AECOM TECH. SERV., INC.
ROANOKE, VIRGINIA
UTILITY ENGINEER

PROJECT 0081-011-120	SHEET NO. 18(5)
--	-------------------------	--------------------

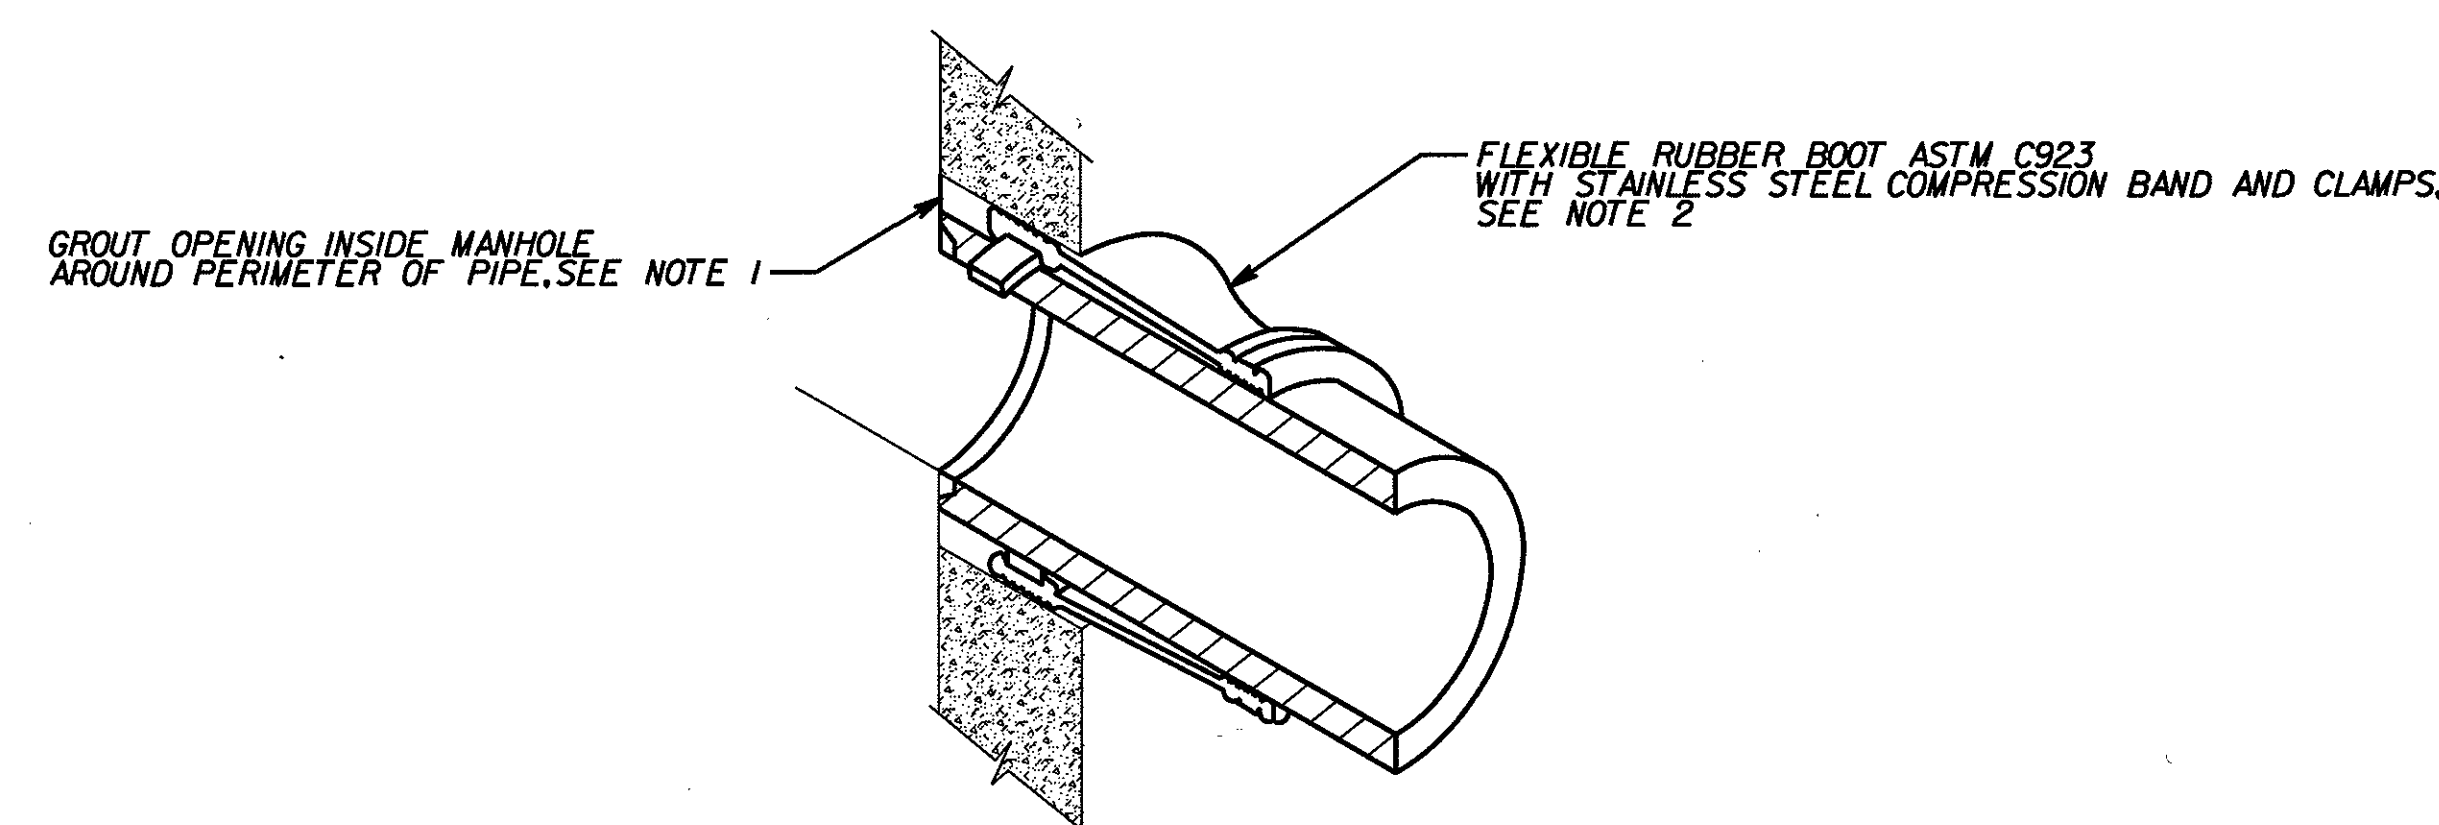
REPLACE 259 LF
SANITARY SEWER PIPE
PER NOTE 1 THIS SHEET
Pressure Tested 4-25-16
PASSED

REPLACE 68 LF
SANITARY SEWER PIPE
PER NOTE 1 THIS SHEET
Pressure Tested 4-25-16
PASSED
